**CC1070 Errata Note 001, rev. 1.0**

December 6, 2005

**Figure 1: Recommended PLL calibration procedure**

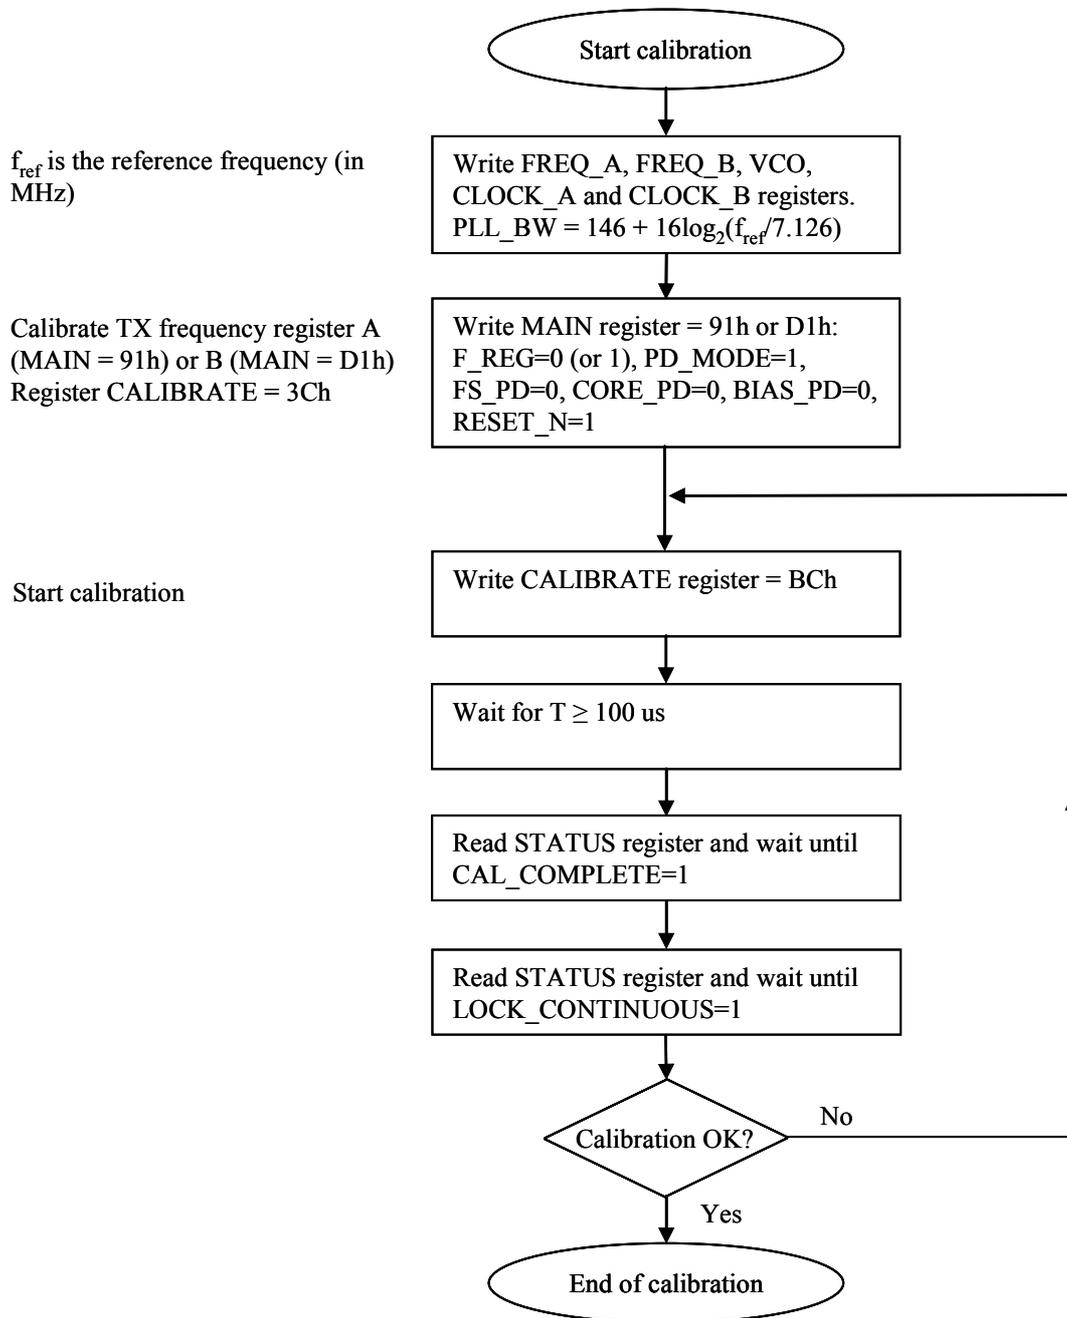
In less than 10 ppm of all PLL calibrations performed it was observed that CC1070 did not achieve LOCK even when introducing a 100  $\mu$ s wait period before polling of [STATUS.CAL\_COMPLETE] was initiated. The reason for no LOCK still occurring, even when calibrating the PLL with this small wait period, is due to the PLL calibration procedure making an erroneous frequency measurement causing the PLL calibration algorithm to choose a wrong capacitor array setting producing a no LOCK situation. For this reason it is important to control that the PLL calibration achieves LOCK and recalibrate if it does not.

For those users who have not already implemented a recalibration procedure in software it is strongly recommended to avoid polling [STATUS.CAL\_COMPLETE] until 100  $\mu$ s has elapsed following calibration start, then monitor LOCK after calibration complete and, if LOCK is not achieved, recalibrate until LOCK is successfully achieved. The recommended calibration procedure, including recalibration, is provided in figure 1.
